**Review and Advise**

The developers of Marriott Courtyard Hotel at 8<sup>th</sup> and R Streets have further developed their sign package and seek the Commission's input.

**EAST ELEVATION**  
SCALE: 1/32" = 1'-0"

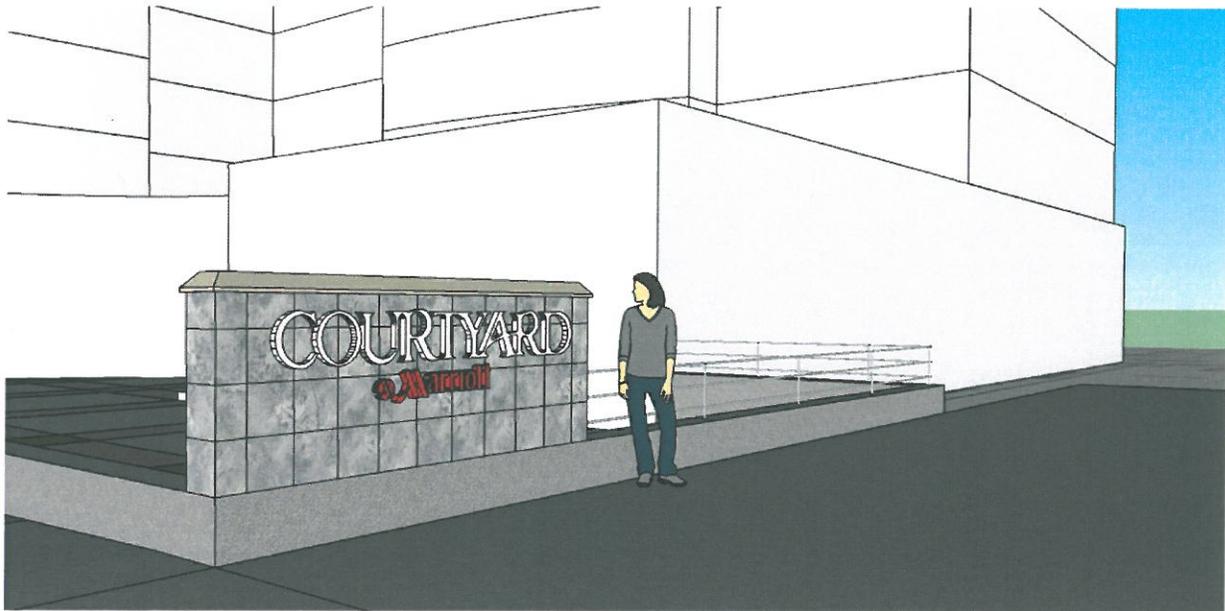
The developers and hotel have agreed to use consistent designs (individual channel letters) on all the signs high on the facades (south, east, and north).

The signs on the canopy in the R St. right of way have been set aside for further discussion.

The monument sign for the east wall of the entrance plaza has been more clearly depicted. If the museum is developed east of the hotel, the intention is to remove the north part of the wall, while retaining the

monument sign on the south part of the wall. The backing of the sign would be slate.
